DeKalb County Historic Preservation Commission

Monday, June 15, 2026- 6:00 P.M.

Staff Report

E. 1895 Edinburgh Terrace, Rich Brasher. Construct an addition on the rear of a nonhistoric garage and replace windows and doors on the rear of a historic house. **1248164.**

9'-6" x 10' Storage Addition Behind Existing Garage

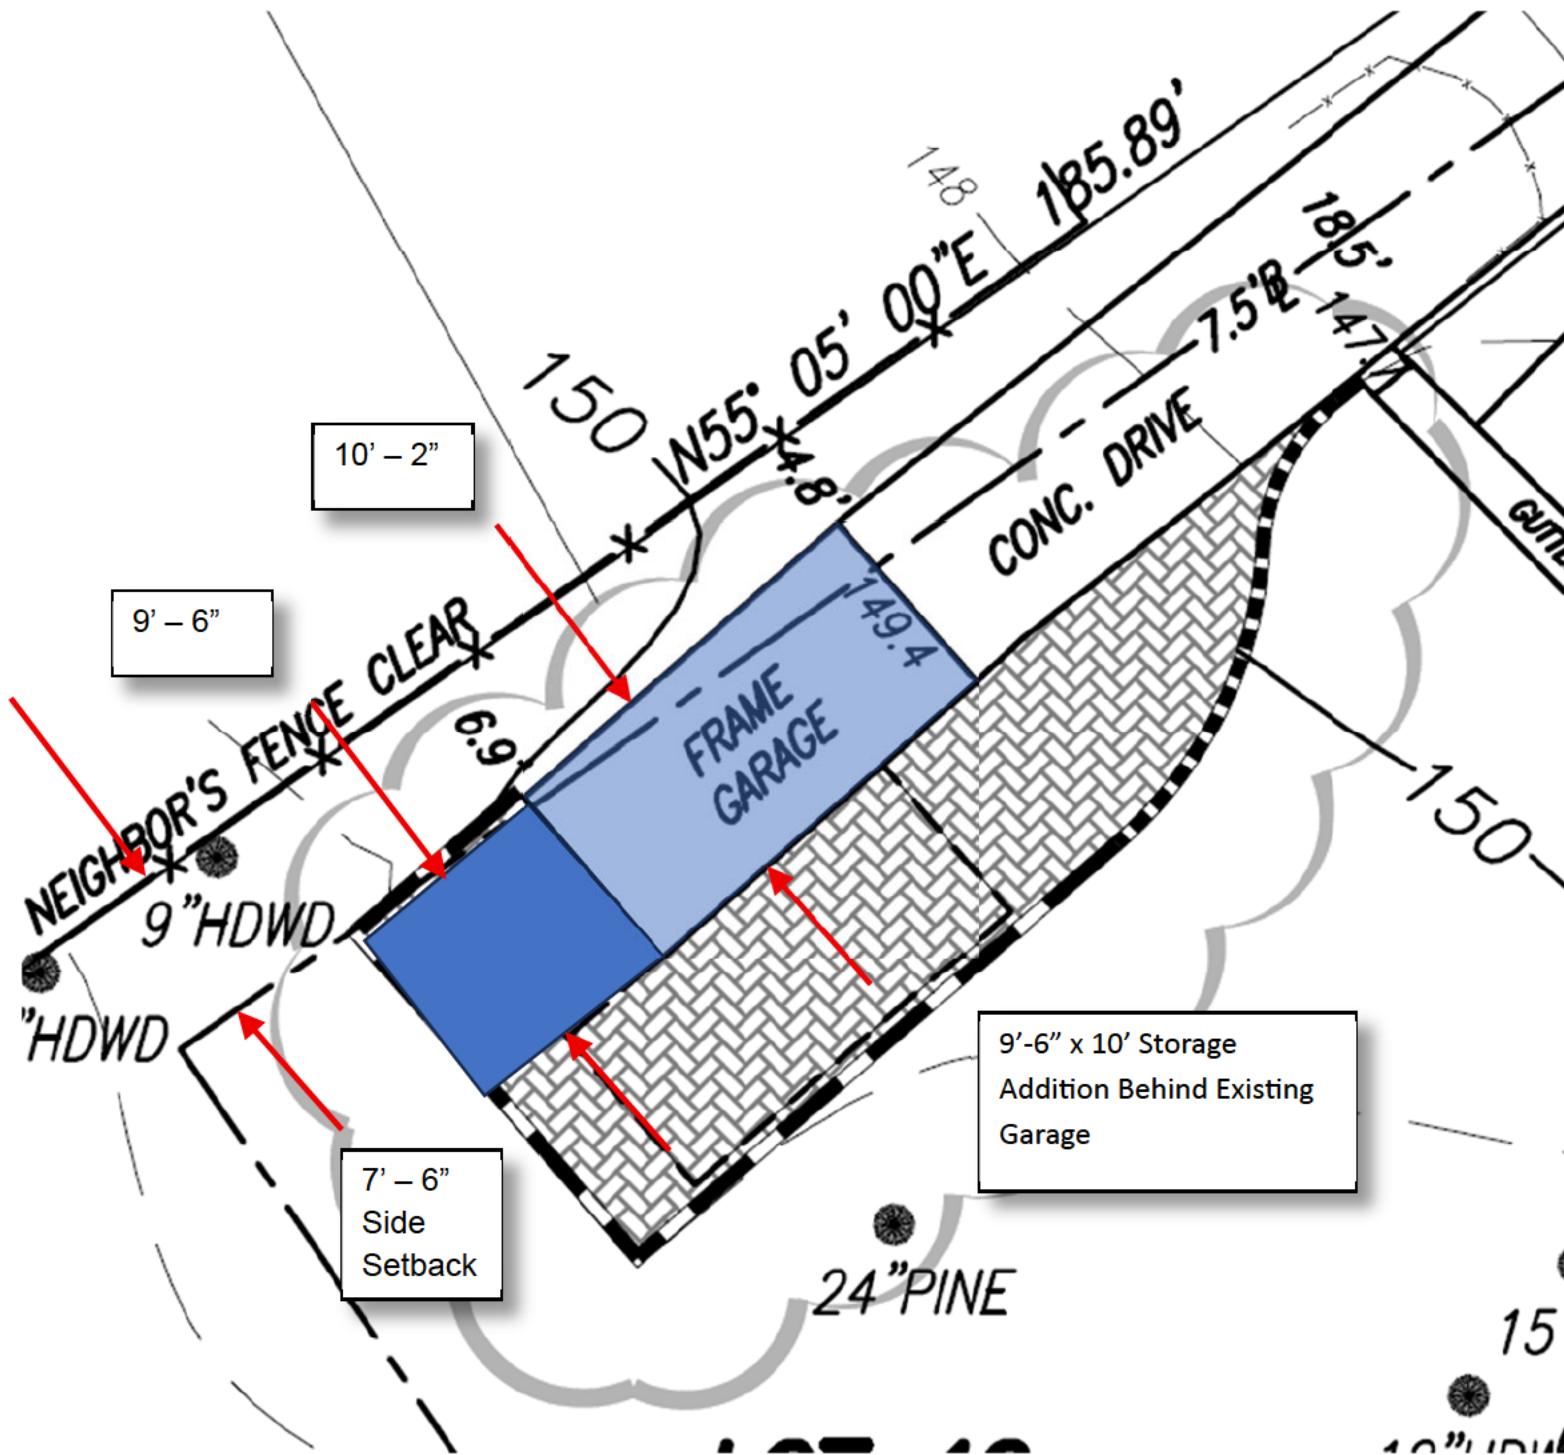
1. Construct an addition the rear of a nonhistoric garage. A storage area extension, measuring roughly 10' x 10' will be constructed on the rear of a nonhistoric garage, near the Northern property line. The storage addition will be constructed with board and batten siding to match the existing gable ends of the garage, a polycarbonate panel shed roof, and wood shutters original to the existing garage.

Approve. These proposed changes do not appear to have a substantial adverse effect on the district. This application appears to meet the guidelines and the staff recommends approval.

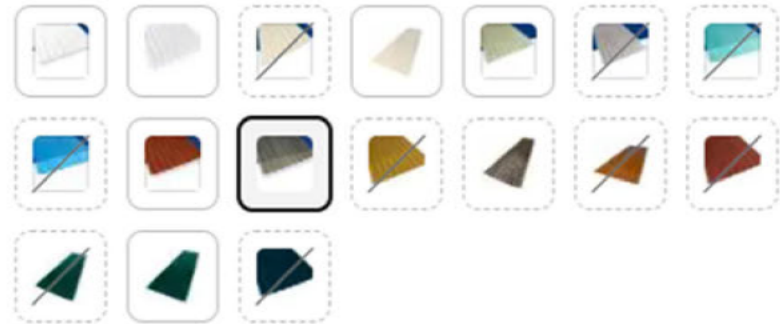
These shutters were found in the attic of the existing garage. They will be repurposed to provide ventilation into the storage area by being incorporated into the rear gable-end of the storage addition.

Polycarbonate roof panel to provide interior illumination, as there will be no lighting inside.

1895 Edinburgh Terrace NE

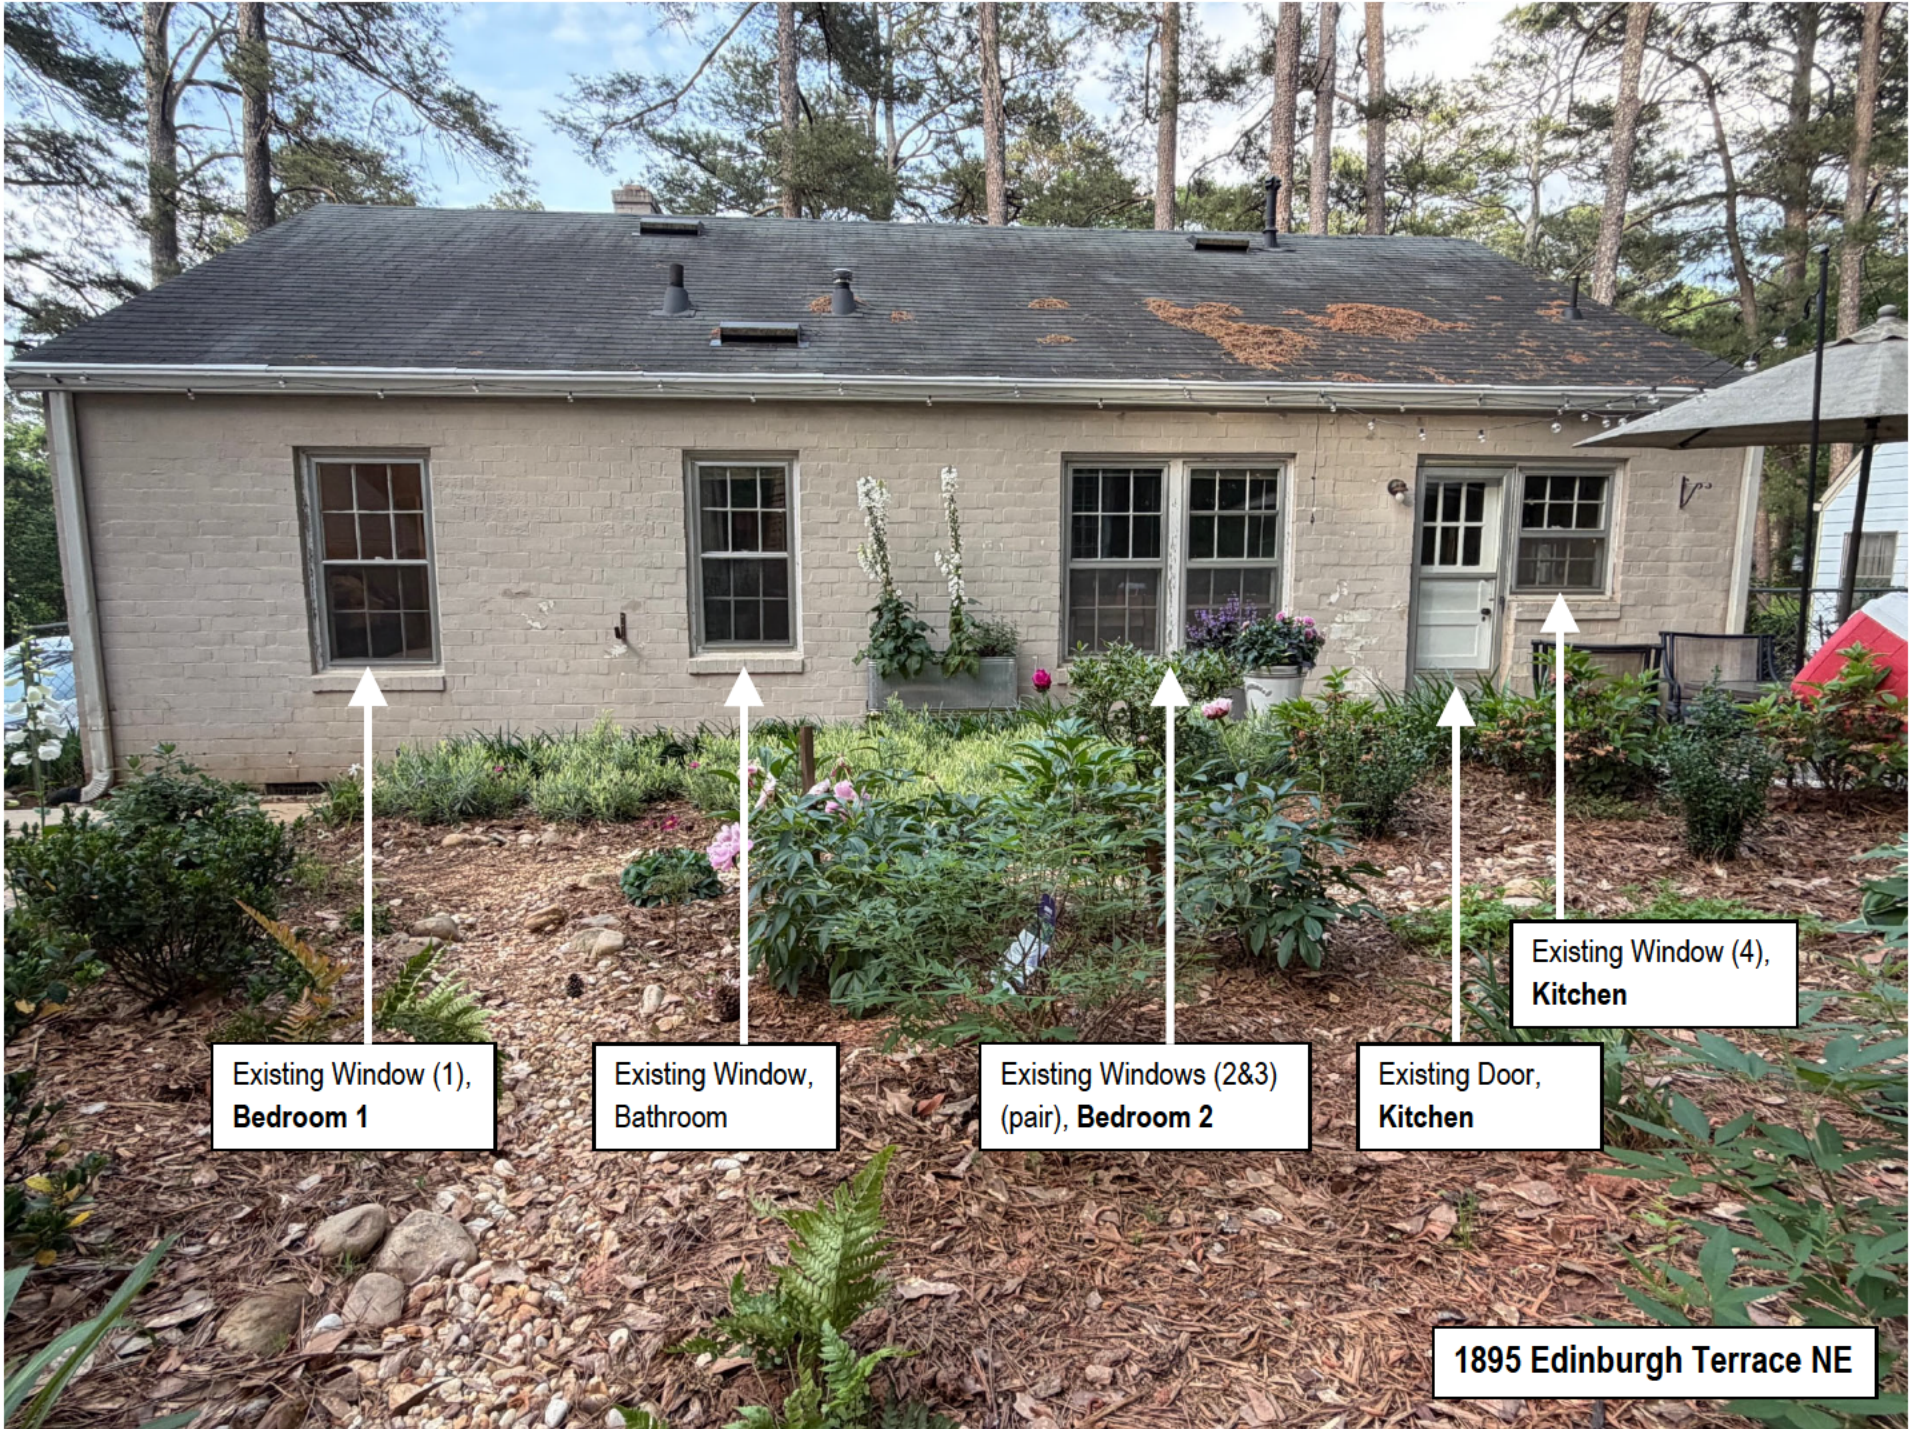
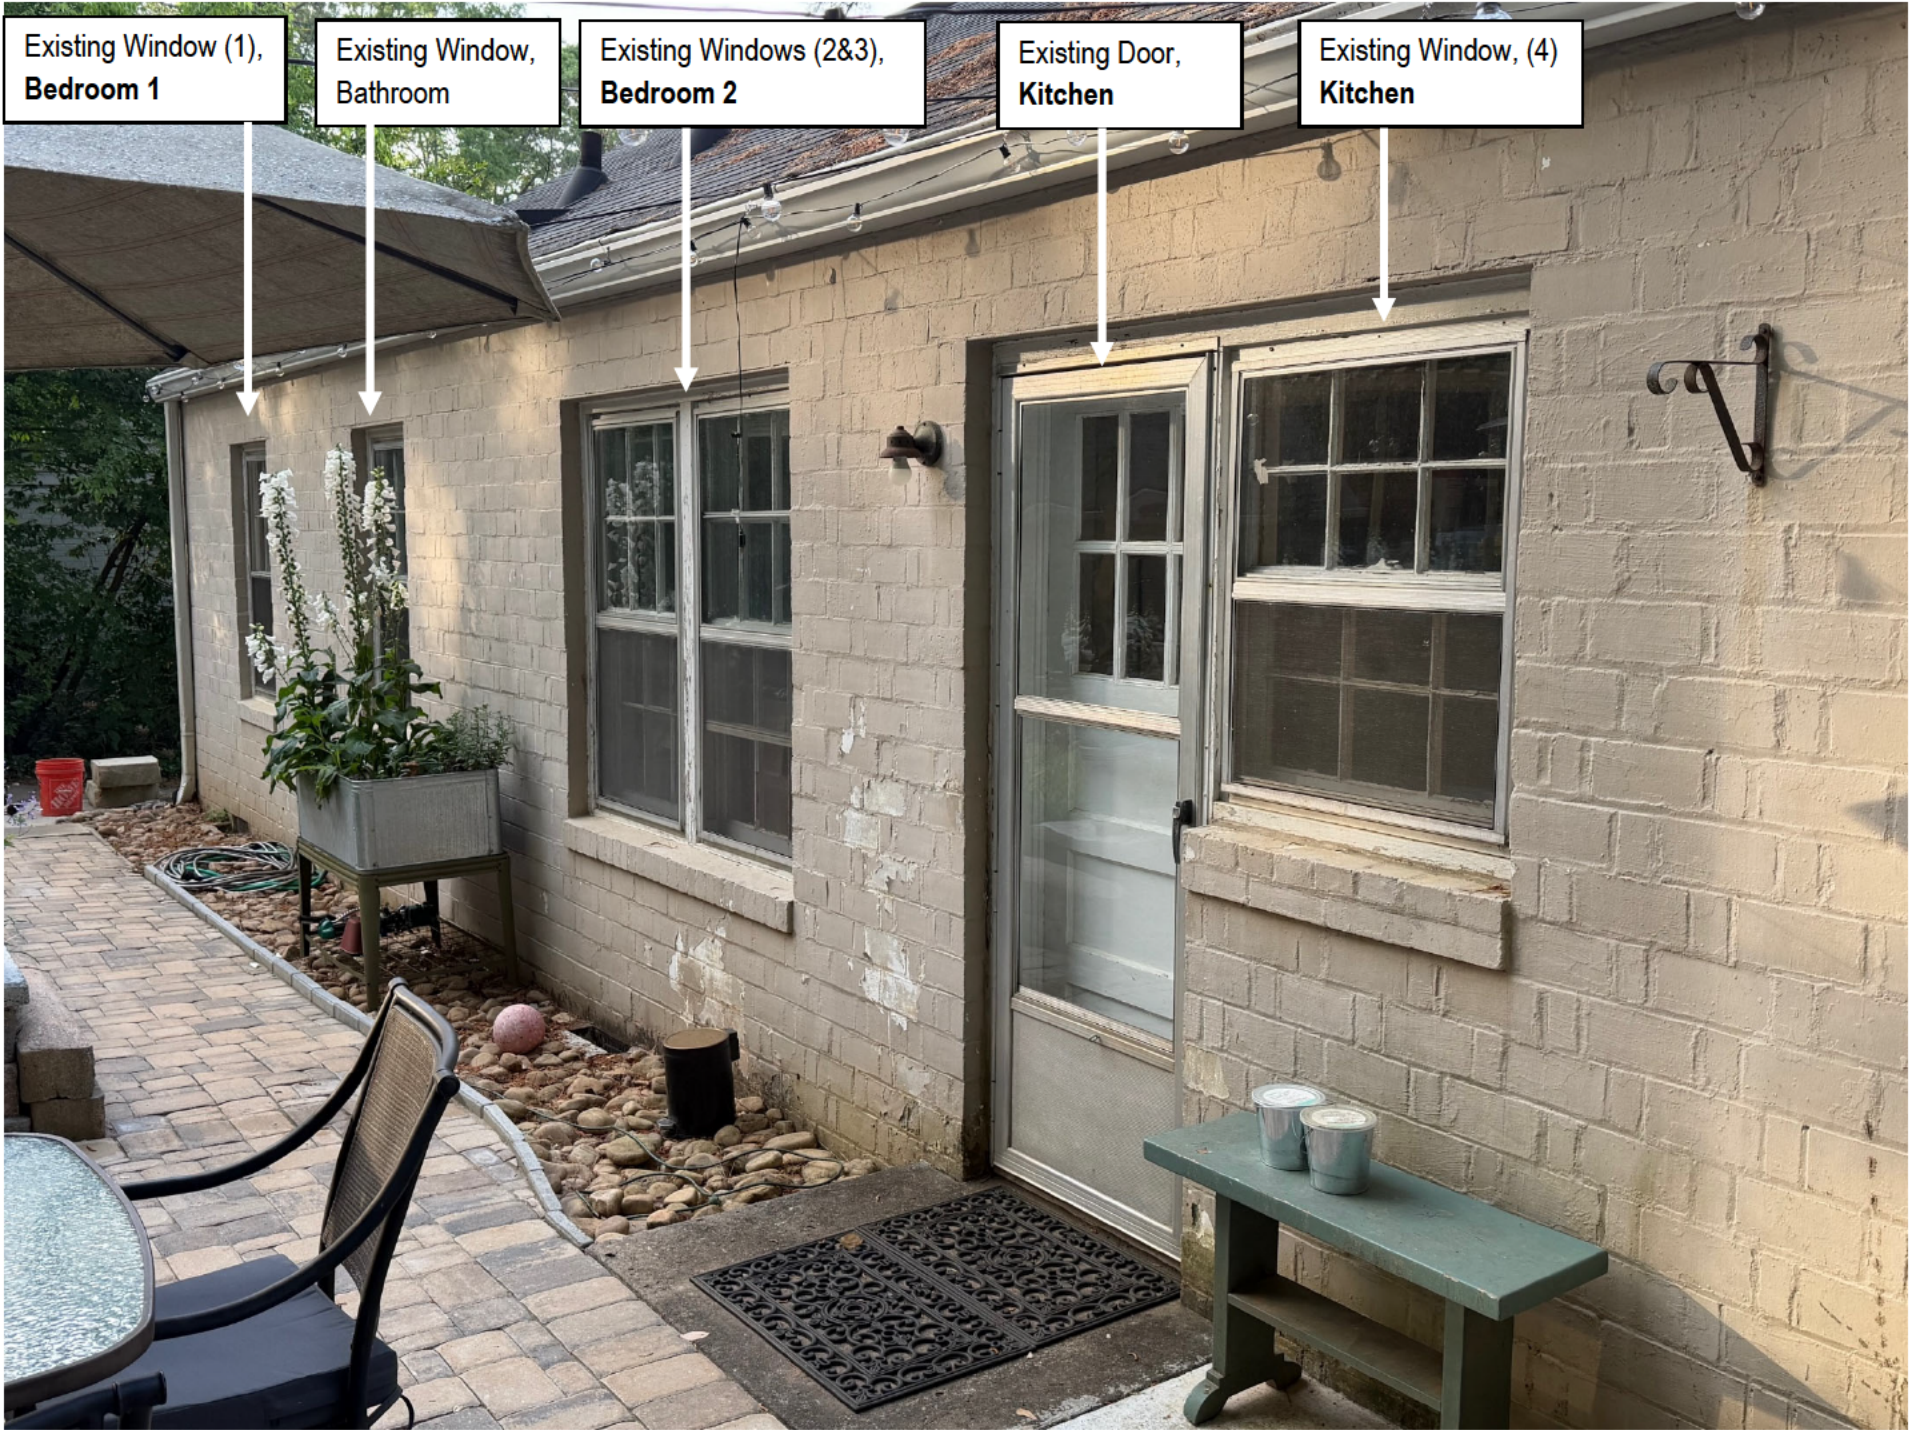
2. Replace three windows along rear facade of house with three doors. Three double-hung windows on the rear façade of the house will be removed and replaced with new doors to match the width of the existing window jams. The window openings near the Northern property line will be replaced with French doors and the window toward the Southern property line will be replaced with a wood Dutch style door.

3. Shift an existing rear door from kitchen to rear yard. The existing rear door will be relocated to the rear façade of the house, so it is centered in the kitchen of the house. New door location replaces a fourth existing window on the rear of house. The relocated door entrance will be bricked with reclaimed brick and painted to match existing exterior.

Replace Window
w/ full-lite French
door, swing out,
hinge on left

Replace Windows
w/ pair of full-lite
French doors, swing
out, operable door,
hinge on left

Brick up existing
door location w/
bricks reclaimed
from French door
installations

Replace Window
w/ Dutch door,
divided lite upper,
solid lower, swing
out, hinge on right

Small decks will be incorporated over area with river stones for transition from bedrooms to the rear walkway.
